SERVICE LETTER NO. 78  
FEBRUARY 1, 1951

SUBJECT: FUEL SYSTEM ACCUMULATOR TANK MAINTENANCE AND MODIFICATION

SUBJECT	Fuel Accumulator Tank - Replacement
EFFECTIVITY	All Navions
DRAWING	Tanks experienced corroding Item # 2307 P/N 145-48004 Replacement tanks - Item # 2307-10 P/N 145-48006

FUEL SYSTEM ACCUMULATOR TANK MAINTENACE AND MODIFICATION

Figure 1 - Accumulator Tank Bracket

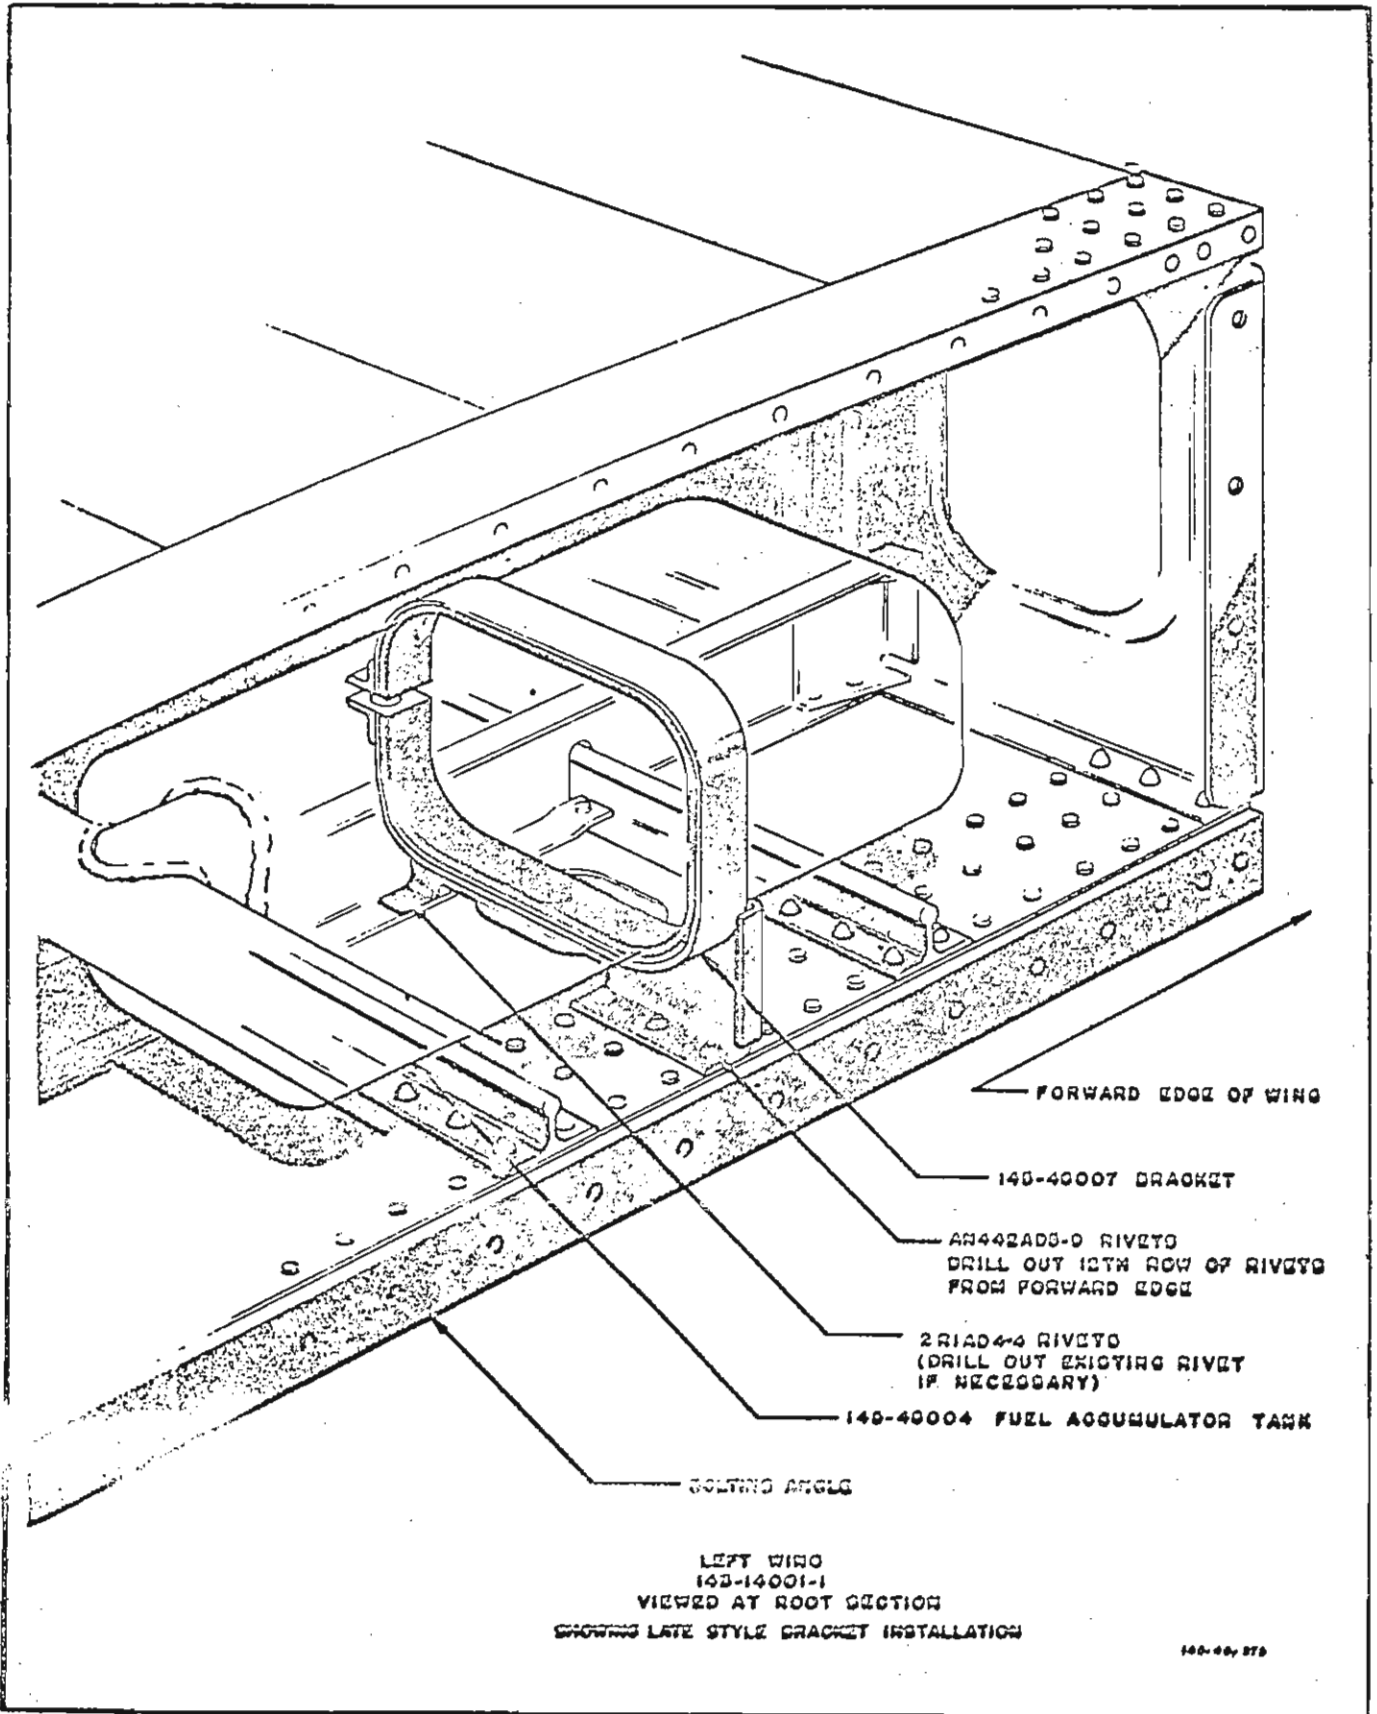
Navion airplanes prior to factory serial number NAV-4-1251 have the fuel accumulator tank supported by two 145-48008 brackets riveted to the 143-14010-20 center rib. Airplanes subsequent to NAV-4-1251 have the fuel accumulator tank supported by one 145-48007 bracket, riveted to the bolting angle of the left wing.

1. Inspect inside the root section to see if fuel accumulator tank bracket 145-48007 is installed. If the 145-48007 bracket is installed, remove it from the wing as follows:
  - a. Drill out the three AN442AD5-9 rivets which attach one end of 145-48007 bracket to the wing bolting angle. This is the 12th row of rivets aft of forward edge of the wing.

- b. Drill out one 2R1AD4-4 rivet attaching the outboard end of the 145-48007 bracket, and remove bracket from wing.
- c. Replace the first three removed rivets with AN442AD5-8 rivets. Replace the removed outboard rivet with one 2R1AD4-3 rivet.

1. Inspect the inside root section of left wing to see if the 145-48007 fuel accumulator tank bracket is installed. If bracket is not present, install the new 145-48007 bracket, received as a loose part, as follows:
  - a. Drill out three AN442AD5-8 rivets which run spanwise in the bolting angle. This is the 12th row of rivets aft of the forward edge of wing.
  - b. Clamp 145-48007 bracket in the wing with the flange of bracket over holes just drilled. Drill through bolting angle holes and bracket flange with a No. 21 (.159) drill.

CAUTION: Do not elongate holes in bolting angle.
  - c. Attach bracket to bolt angle with three AN442AD5-9 rivets.
  - d. Drill through rib, wing skin, and pilot hole on outboard flange of bracket with No. 30 (.128) drill, and install one 2R1AD4-4 rivet.
